Construction Division
Additions & Alteration Charges Approval Form

Quality Control Check Report Stage: After Plumbing & Electrical (Apartments)

GULMOHAR RESIDENCY

Details of Additions & Alterations

D-602 (check)

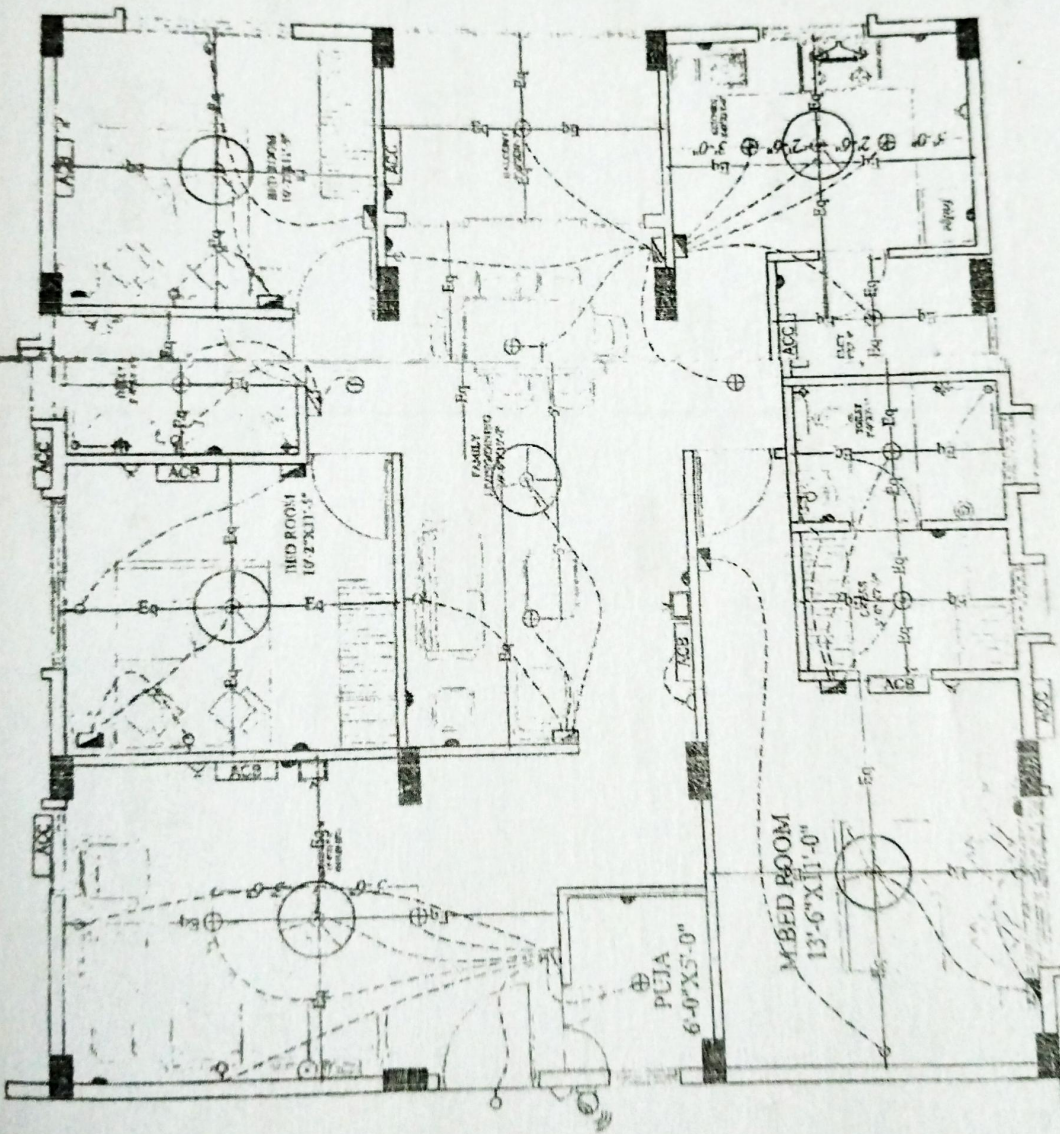
S No.	Room	Civil work near pipes in balcony & utility ⁷ (✓ or ✗)	CPVC & PVC Check ⁵ (✓ or ✗)	Electrical points check ⁶ (✓ or ✗)	Water proofing check ⁸ (✓ or ✗)	Proper use of fasteners check ⁹ (✓ or ✗)	Placement of DB ¹⁰ (✓ or ✗)	Placement of Generator changeover (✓ or ✗)
1	Bedroom 1 m. bed	-	-	✗	-	-	-	-
2	Toilet 1 m. Toi	-	✓	✓	✓	✗	-	-
3	Bedroom 2 k. bed	-	-	✗	-	-	-	-
4	Toilet 2 c. Toi	-	✓	✗	✓	✗	-	-
5	Bedroom 3 k. bed	-	-	-	-	-	-	-
6	Toilet 3	-	-	-	-	-	✓	-
7	Drawing	-	-	✓	-	-	-	-
8	Dining	-	-	✓	-	-	-	-
9	Lobby 1	-	-	-	-	-	-	-
10	Utility balcony 1	✓	✓	✓	-	✗	-	-
11	Utility balcony 2	✓	✓	✓	✓	✗	-	-
12	Utility balcony 3	-	-	-	-	-	-	-
13	Kitchen	-	✓	✓	-	-	-	-
14	Other pooja	-	-	✗	-	-	-	-
15	Other	-	-	-	-	-	-	-
Remarks Note: 1) In m-bed AC point was missing. 2) In k-bed, k-bed light point's were missing.								
Remarks on additions & alteration sheet: Note: 1) In A4A they didn't mentioned the date.								
Signed by engineer.

Revised drawing required from HO

Changes in electrical points: (mark on plan)

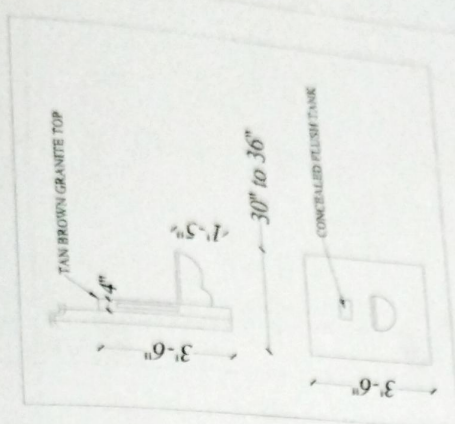
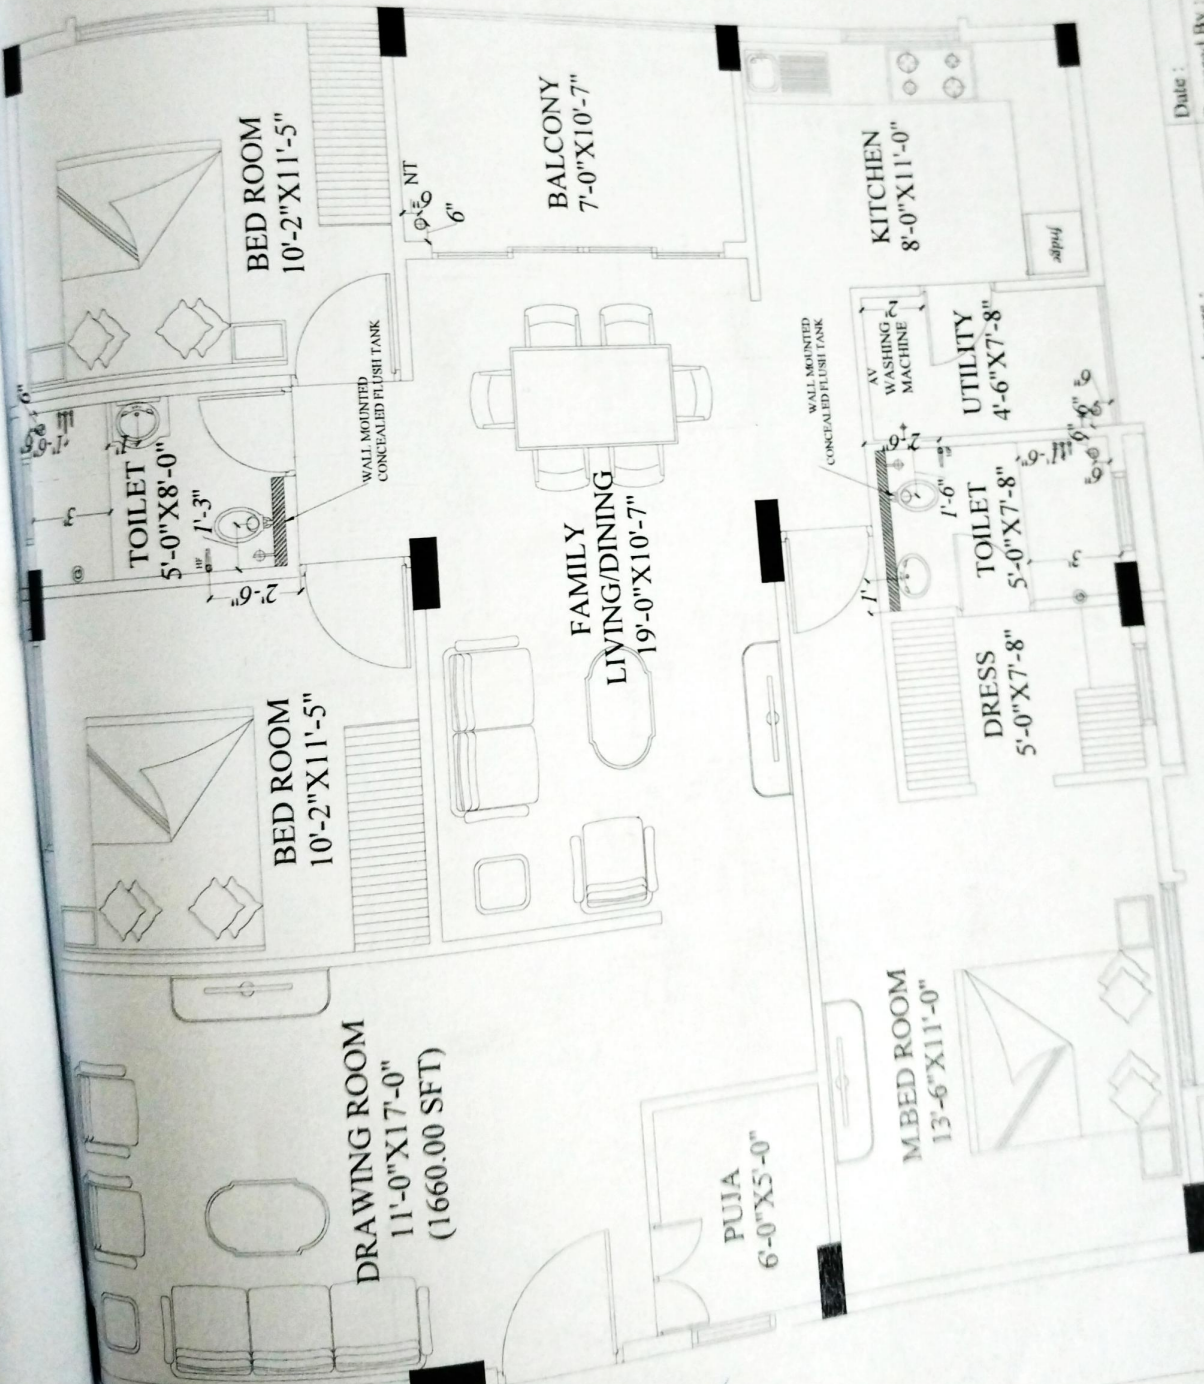
① All CP and Sanitary by customer ✓

① Granite by customer.
